**BEFORE THE PUBLIC UTILITY COMMISSION**  
**OF OREGON**

Docket No. LC 73

2019 Integrated Resource Plan.

Staff Final Comments

Figure 1: Capacity need across Need Futures and impact of contract expirations<sup>5</sup>

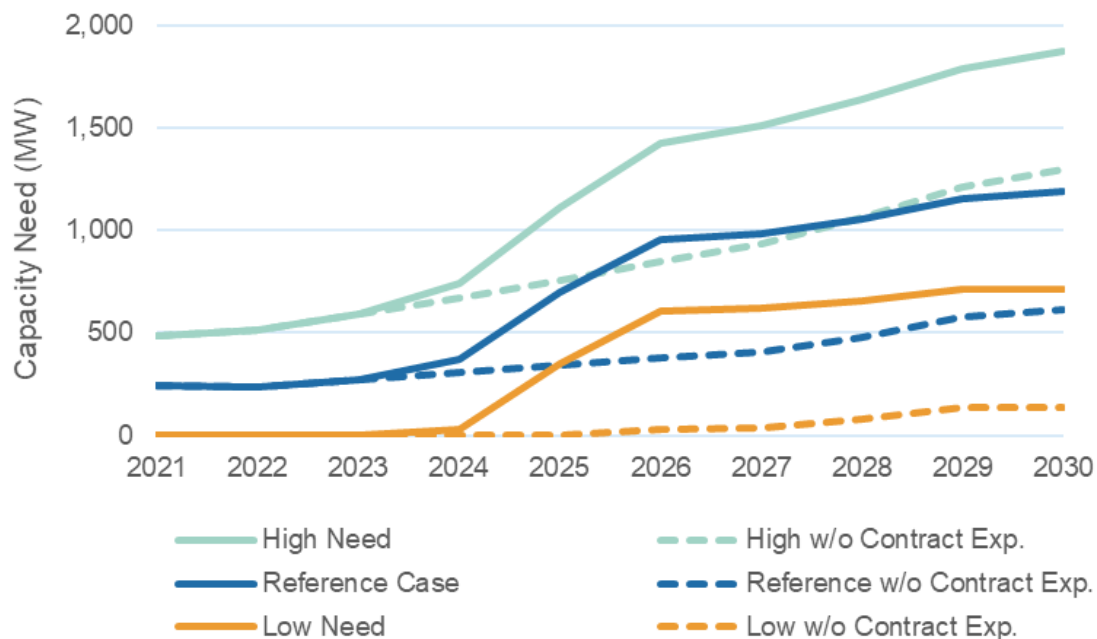
As noted in Table 1, PGE plans to use a staged approach to meet this range of potential capacity needs. Under the staged approach, the Company will pursue bilateral agreements for existing capacity resources first. Then, it will reassess its capacity needs, update the Commission, and release a 2021 or later RFP for a to-be-determined amount of non-emitting capacity.

Figure 2: E3 Market Capacity Assumptions Used to Model Capacity Need:<sup>15</sup>

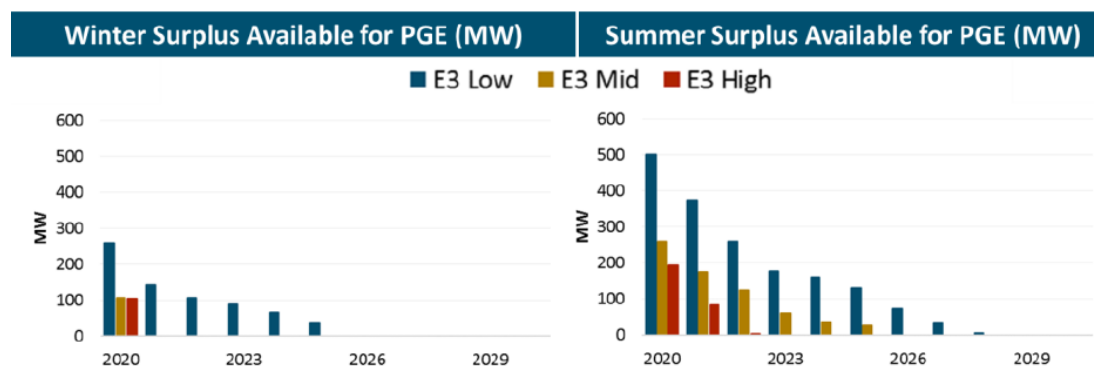
PGE's modeling includes assumptions for the availability of regional capacity and imports from California and British Columbia. Staff notes that these amounts, supplied by E3, correspond with the assumption that no more regional generation resources will be built. Staff finds this an acceptable standard for now, so long as the assumption holds into the near future.

Staff plans to recommend an IRP acknowledgement condition that PGE monitor and report on this key assumption as part of any RFP and in the 2021 update to LC 73, as market conditions may encourage the building of more generation resources regionally.

Figure 5: NREL Battery Cost Projections<sup>32</sup>

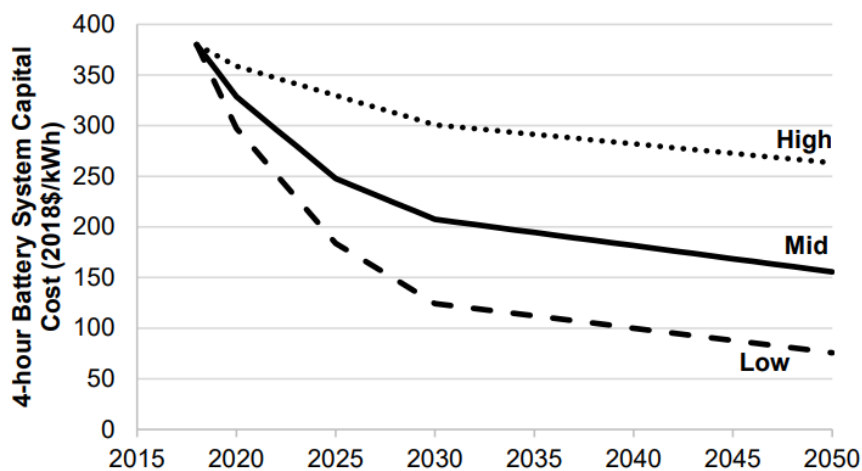
Staff agrees that battery technology is likely to improve rapidly. In the time since PGE’s 2019 IRP was filed, it has become apparent that battery costs are falling more rapidly than PGE’s modeling assumptions have anticipated. A recent NREL paper published in 2019 shows that the mid-range of published storage cost projections expect battery storage costs to fall steeply from 2019 through 2021, and then fall an additional ~23% from 2021 through 2026. Even the high cost NREL scenario shows costs falling approximately 7% from 2021 to 2026.<sup>31</sup> This is compared to PGE’s assumptions that battery costs fall less than 10% in the reference case from 2021 to 2026.

Figure 6: PGE Capital Cost Curves<sup>33</sup>

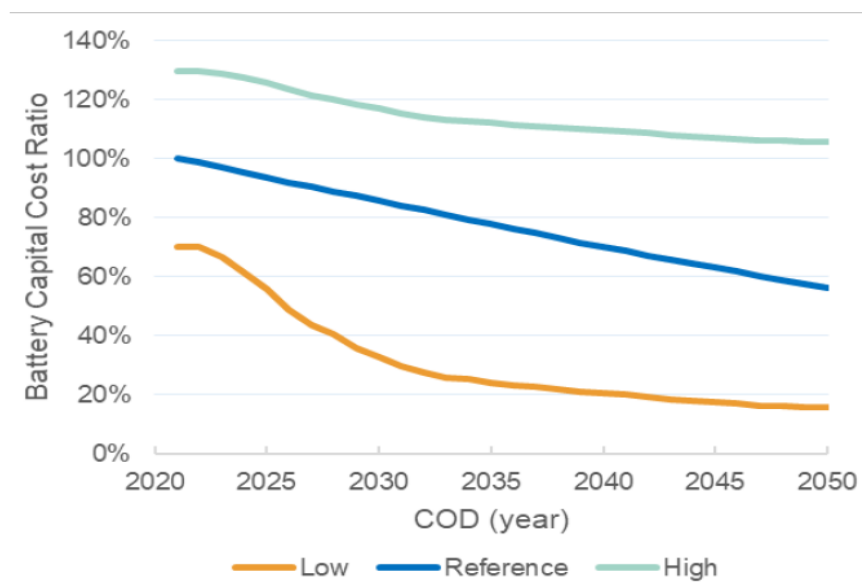
Staff also agrees with PGE that incremental or delayed procurement of large amounts of battery resources may make sense. Relying on batteries to be low-cost, modular, and flexible is likely an important part of a robust non-emitting capacity strategy. However, utilities across the country are still in early stages of learning how to operate large scale battery portfolios. A capacity action that waits for this technology to meet a near-term need may not be the appropriate balance of cost and risk.

Further, PGE’s IRP includes assumptions for a wide range of possible battery storage cost curves. This range is considered in the portfolio modeling that resulted in the selection of both pumped storage and battery storage in the preferred portfolio during the Action Plan window. Staff understands that a mix of capacity resources, such as existing hydro contracts, pumped storage, and battery storage, may provide the best mix of cost and risk for meeting PGE’s near-term capacity shortfall. PGE makes a similar point in its reply comments, stating that, “PGE agrees that the prospect of a regional capacity shortage in the mid-2020s is concerning and that pumped storage resources may be well-suited to meet a portion of the region’s growing capacity needs.”<sup>34</sup> If PGE’s modeling already accounts a wide range of battery cost declines, and selects both pumped storage and battery technology in the Action Plan window, Staff questions what additional risks need to be accounted for with the RFP timing.

Figure 9: PGE's Renewable Glide Path for the Preferred Portfolio<sup>72</sup>

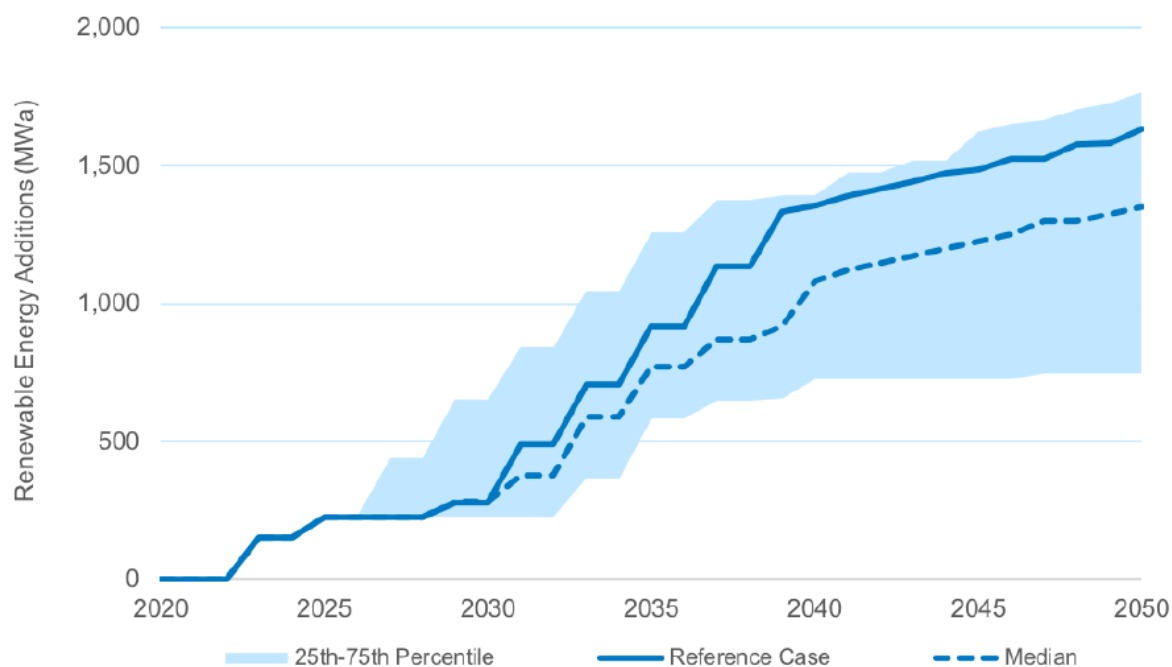
- PGE should not use its market energy position to quantify the bounds of resource procurement.
- In the reference case, the Company will purchase over 200 MWa in the Action Plan window, and will not make another purchase until 2029.

Without additional explanation, Staff finds it difficult to find a concrete justification for why the Renewable Action is the appropriate size. Staff cannot recommend acknowledgement of this item until presented with an approach that aligns more clearly with the IRP’s cost and risk assessment.

Figure 11: Navigant Study Summer Peak Demand Reduction Forecast<sup>95</sup>

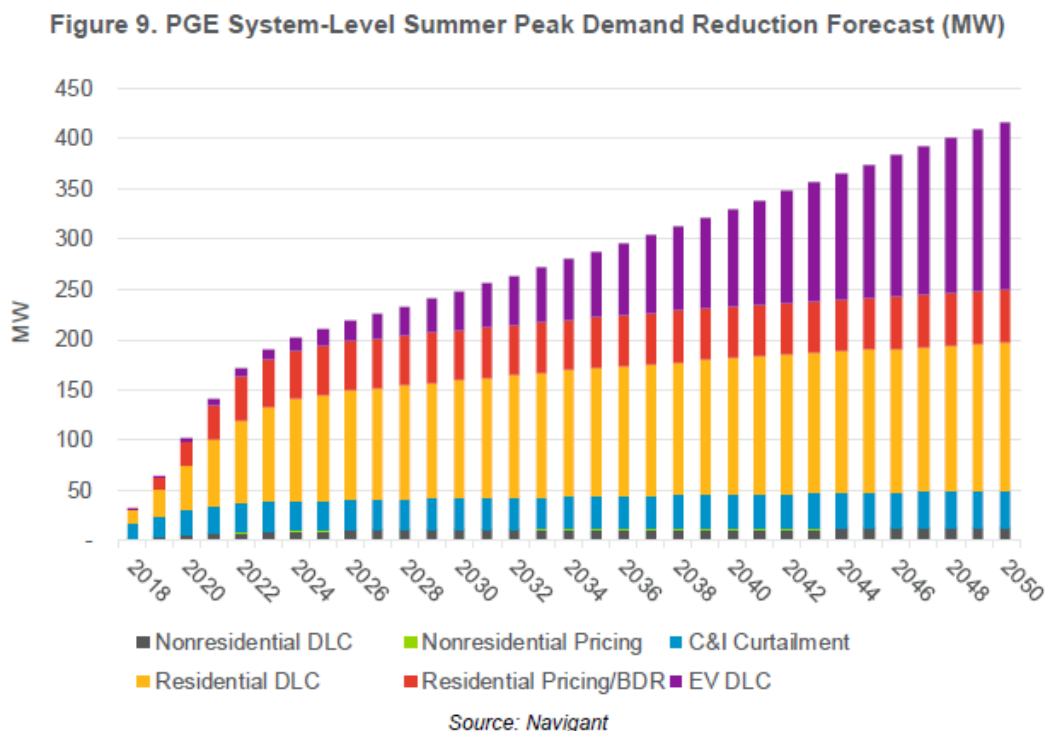
Staff appreciates the growth embodied in the forecast above. However, it falls short of expectations of growth for DR and may signal a troubling turn in PGE’s commitment to DR from the 2016 IRP. The potential shown above is (a) well below a national benchmark average for peak impact from DR, and (b) marks a large decrease from the DR potential found in the previous IRP. First, 2017 research from ACEEE found that most utilities, on average, can reduce peak demand by approximately 10 percent. PGE’s 2024 forecast for DR is approximately 6 percent of forecasted peak. Second, the Brattle Group study used in PGE’s previous IRP identified between 261 - 278 MW of cost-effective, 2021 summer-peak DR from only direct load control programs (DLC) without any customer program crossover. The graphic above shows PGE achieving less than one-half of that amount of DLC by 2025.
